Statement of Work
18-500 Team B5: Melodee Li, Eric Maynard, Aarohi Palkar

Overview of Changes

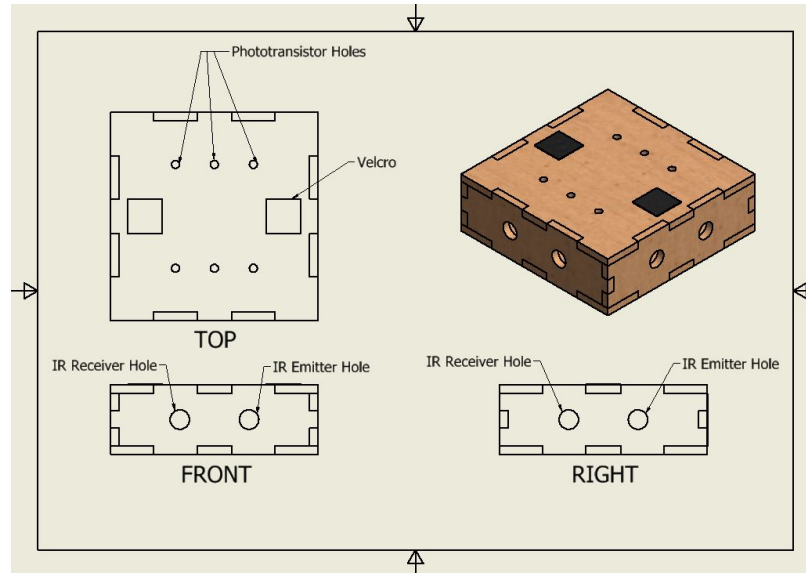
- PCB
 - All components will be through-hole, since we don't have the means to solder surface-mount components.
- Embedded Protocol
 - No change.
- Interpreter
 - Written in python instead of Arduino C.
 - Output is a laptop instead of a robot. Output tiles now contain `print` statements.
 - Deserialization of master tile stream output now done in python as well.
 - GUI to visualize CodeBlox execution and easy identification of errors.
- Tile Enclosures
 - Our original tile enclosure design had multiple puzzle-like pieces (top, bottom, and sides). We were planning to use TechSpark to laser cut wood and glue the pieces together. See below for CAD drawing of original design.

- Since we no longer have access to TechSpark, Melodee and Eric will redesign the tile enclosures and attempt to construct them using a CNC machine and drill at hand. We're not entirely sure what will have to change, but most likely we wouldn't be able to use the puzzle-piece design anymore and will instead create rectangles and glue them together.
